CITY OF ALBUQUERQUE

**RE: Main Event, Pan American Freeway and Vassar Drive
Grading Plan and Drainage Plan
Engineer's Stamp Date 5-07-2015 (File: G16-D149)**

DRAINAGE AND TRANSPORTATION INFORMATION SHEET

**RE: MAIN EVENT,
PAN AMERICAN FREEWAY AND VASSAR DRIVE
GRADING PLAN AND DRAINAGE PLAN
ENGINEER'S STAMP DATE 3-27-2015 (FILE:G-D149)**

DRAINAGE PLAN

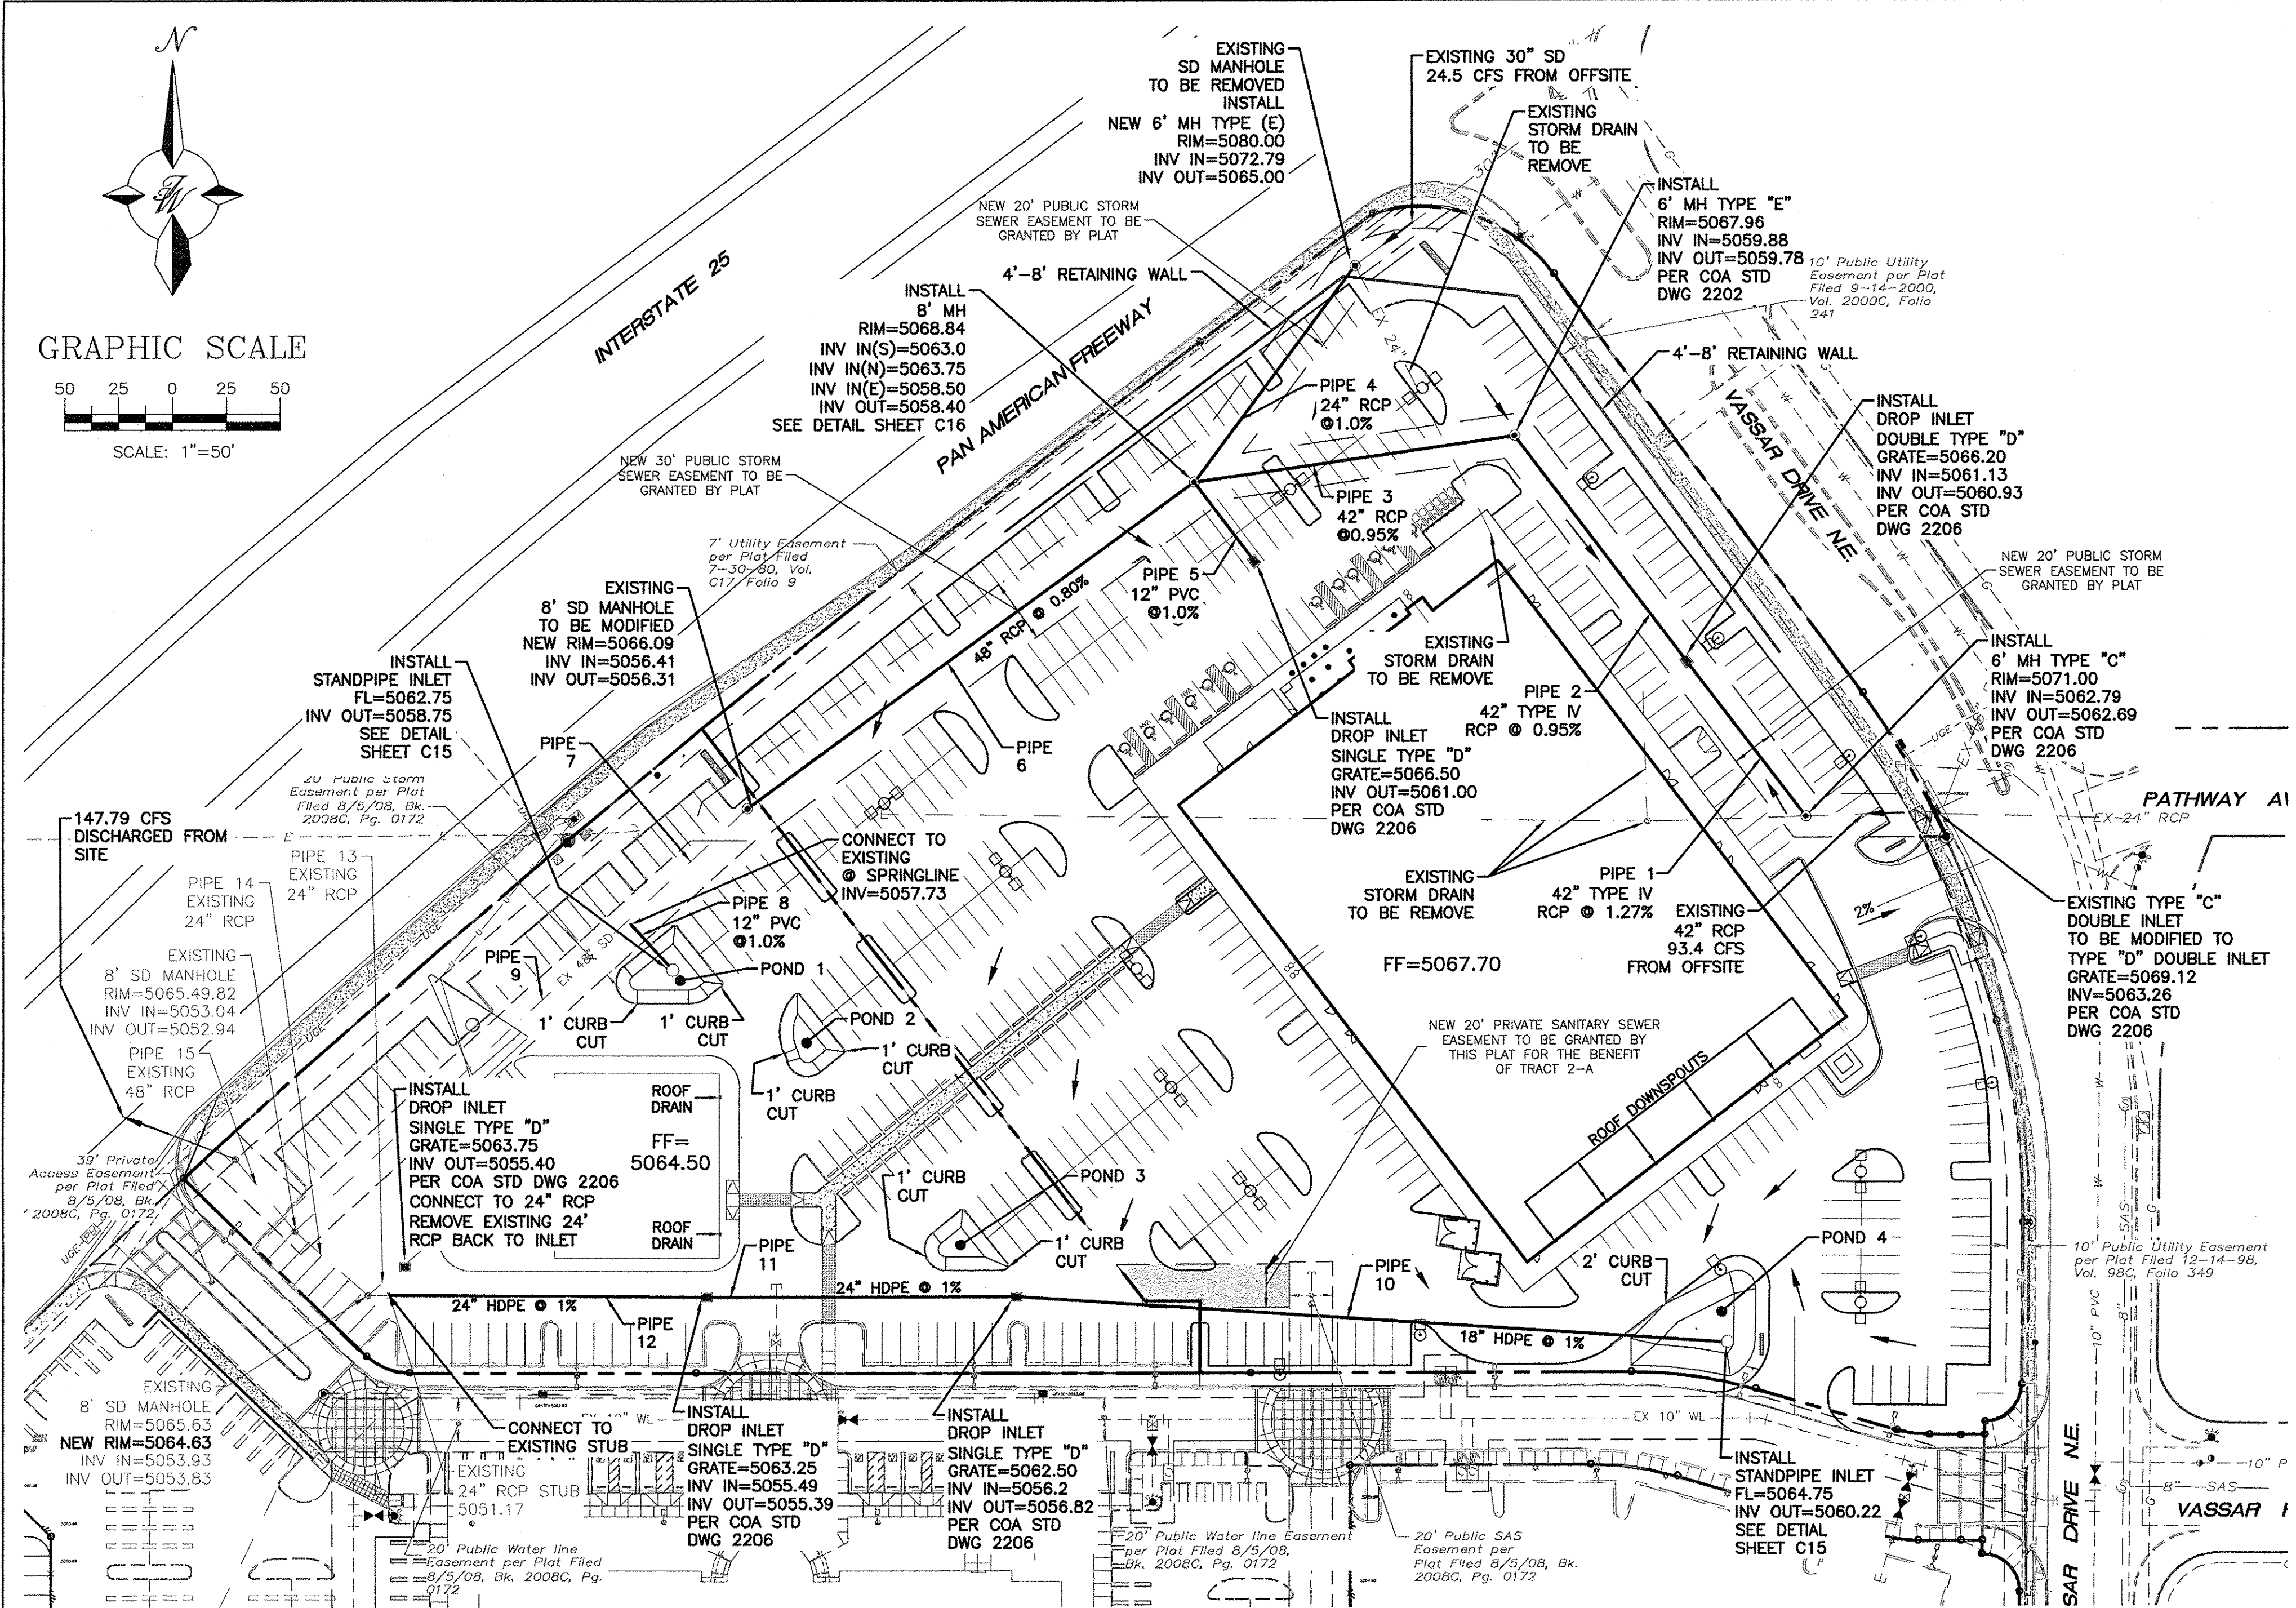
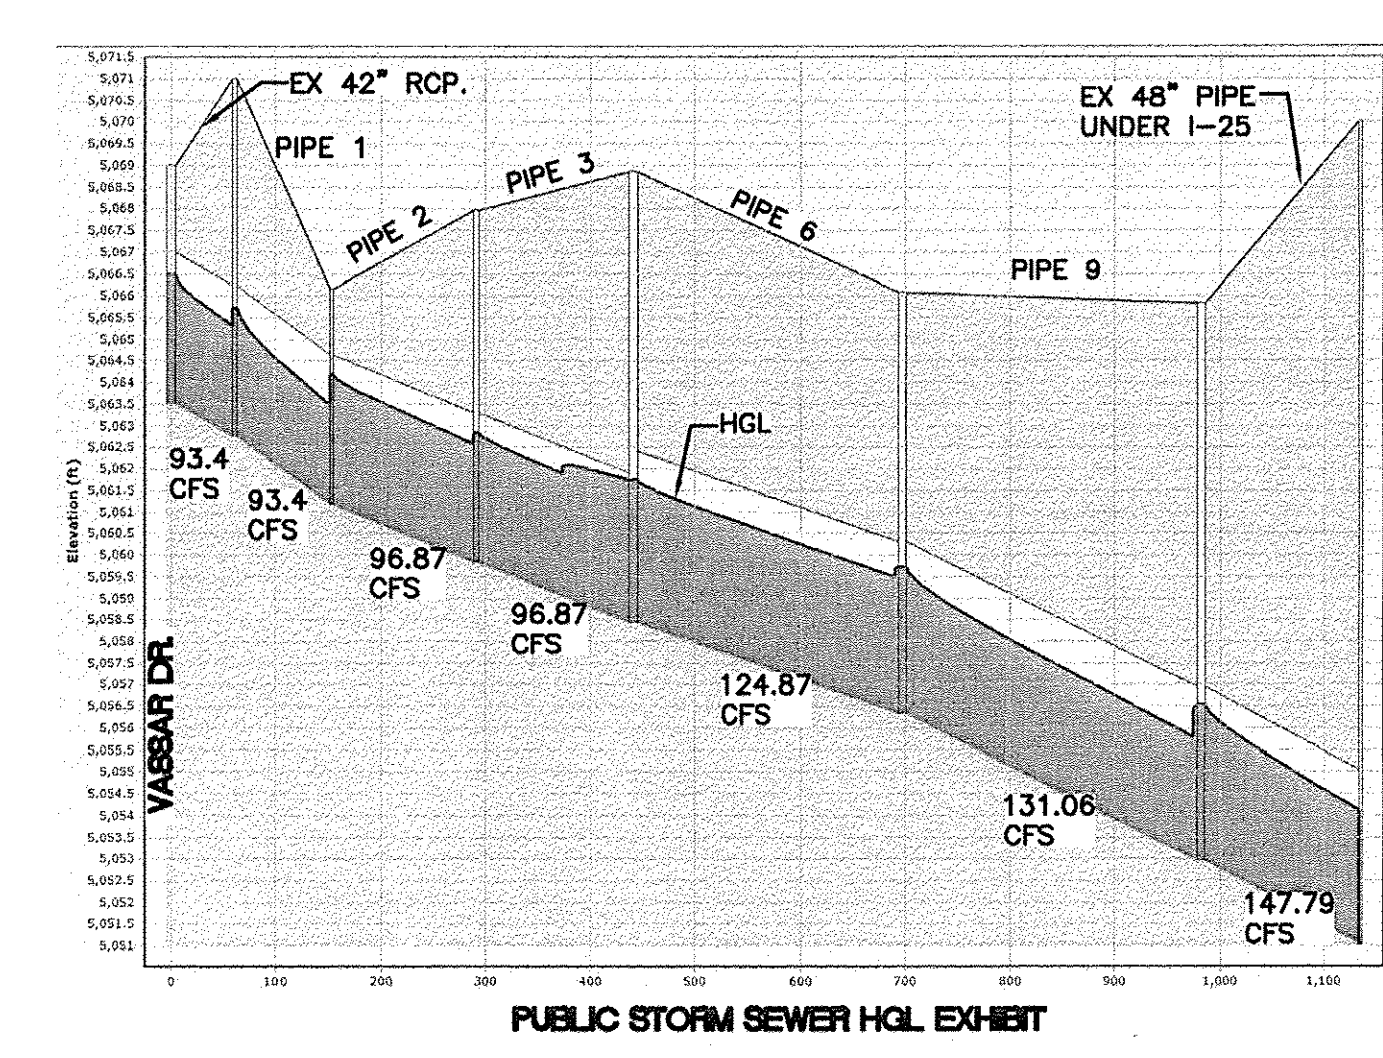
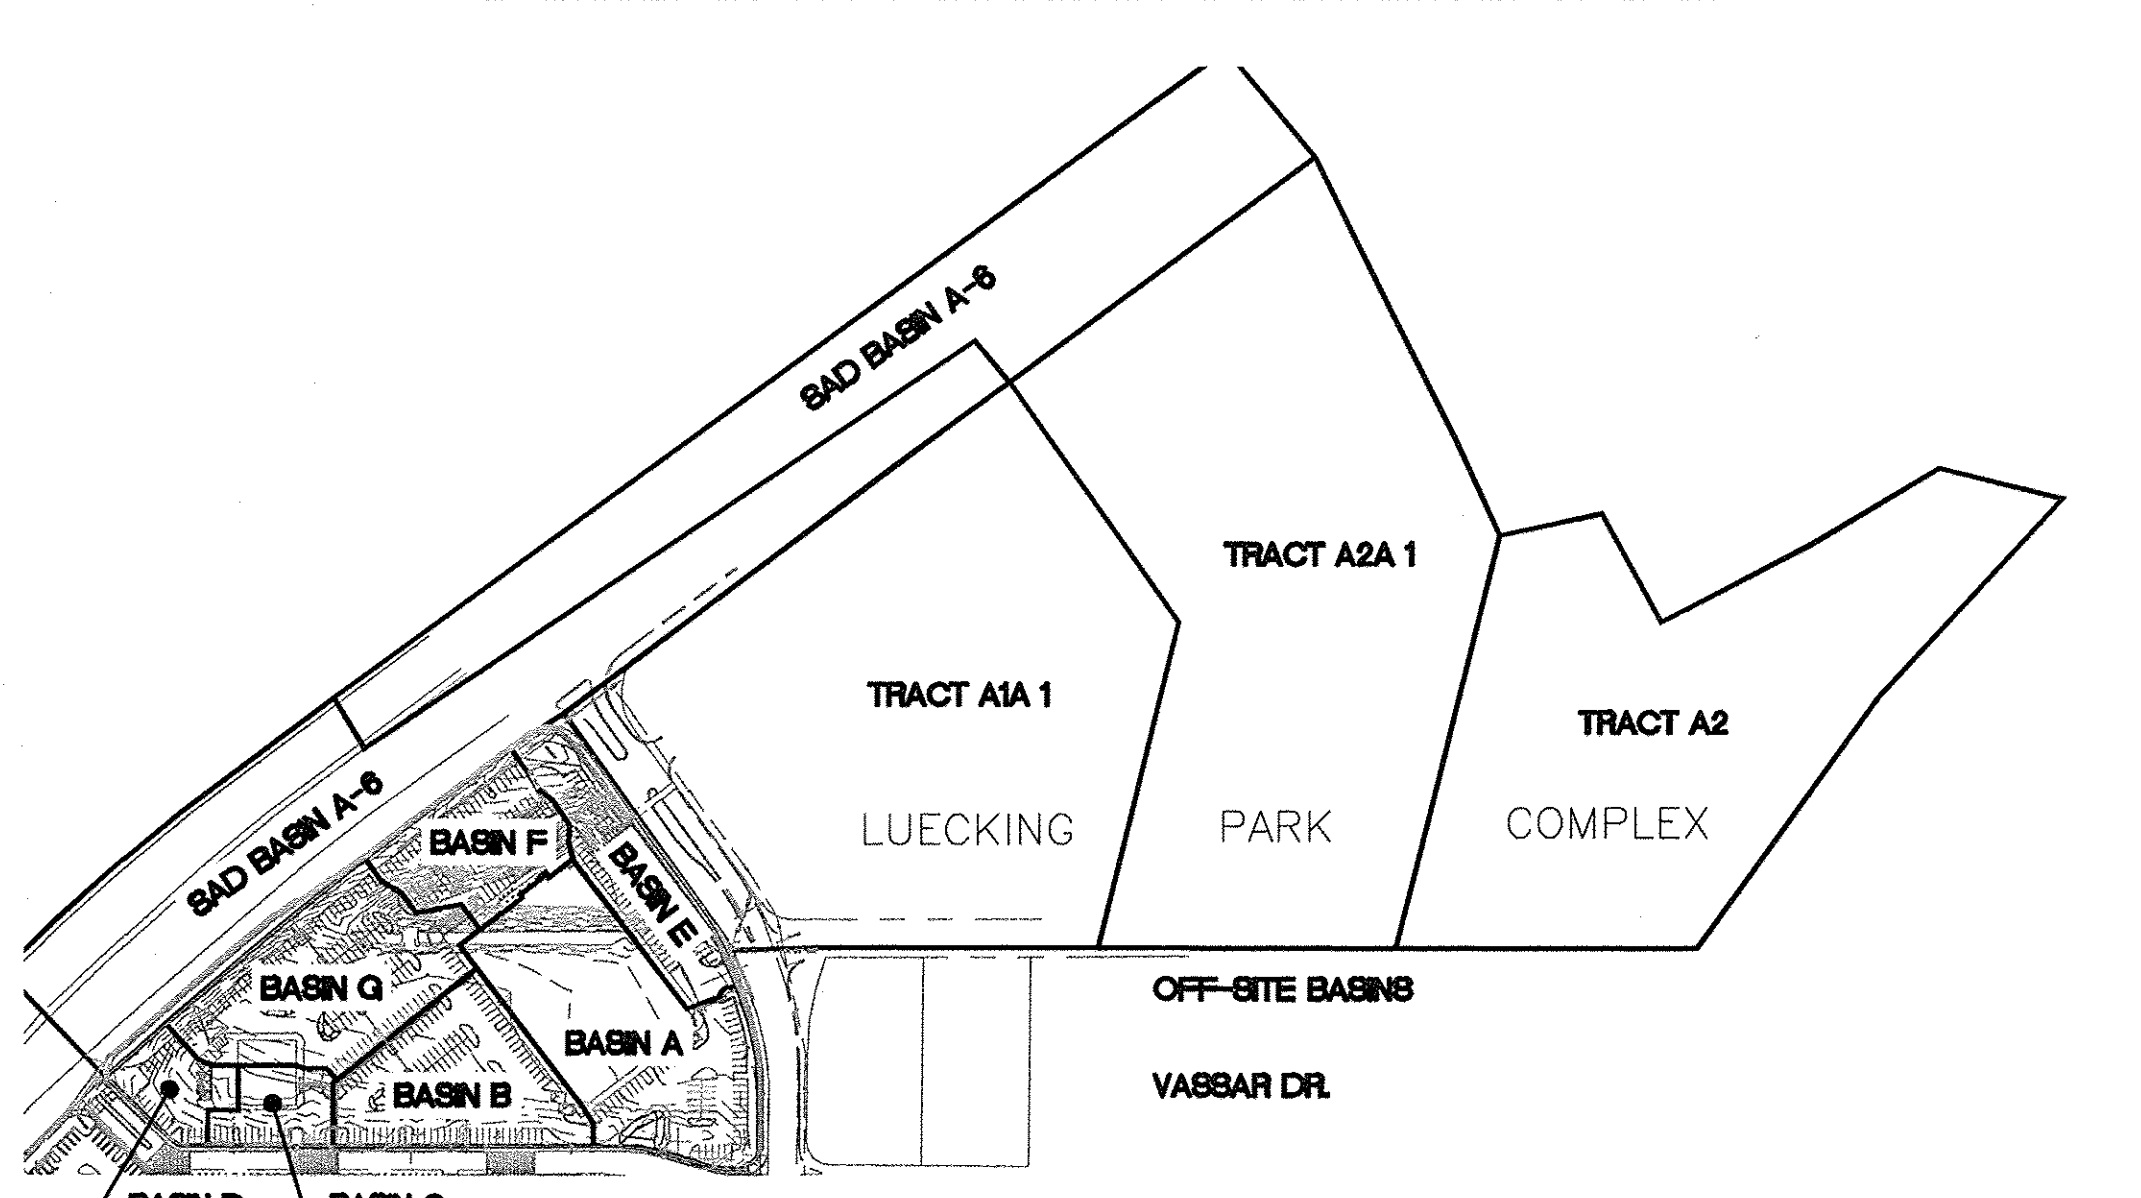
- 1) Label the individual volumes for each of the first flush pond areas, and show spot elevations and contours to demonstrate retention of the required first flush volumes.
- 2) Provide curb cut capacity calculations as applicable for these ponding areas.

1. Show computations for the first flush on this site, and explain how it will manage. The volume required to be retained is 0.34 inches times the impervious area. **The first flush calculations are now shown on Sheet C6.**

4. Include inlet capacity calculations within next submittal and inlet details. Show grate elevations for these inlets on the 'Grading Plan' which correspond to the 'Drainage Plan'.

Capacity of a Single 'D' Storm Drop Inlet

Capacity of the grate:
 $L = 40' - 2(2' \text{ nos.}) - 7(1/2' \text{ middle nos.})$
 $= 32' 1/2'$
 $= 2.7093'$

$W = 25' - 13(1/2' \text{ middle bars})$
 $= 18.5'$
 $= 1.54'$

Area = $2.7093' \times 1.54'$
 $= 4.18 \text{ ft}^2$

Effective Area = $4.18 - 4.18 (0.5 \text{ clogging factor})$
 $= 2.09 \text{ ft}^2 \text{ at the grate}$

Orifice Equation
 $Q = CA \sqrt{2gh}$
 $Q = 0.6 \times 2.09 \sqrt{2 \times 32.2 \times 0.67}$
 $Q = 8.24 \text{ cfs}$

FIRST FLUSH CALCULATIONS:

5.93 ACRES OF IMPERVIOUS AREA = 258,311 SQ. FT
258,311 SQ. FT * (0.34"/12") = 7,319 CU. FT =
0.168 AC-FT OF VOLUME REQUIRED
TO BE RETAINED ON-SITE.
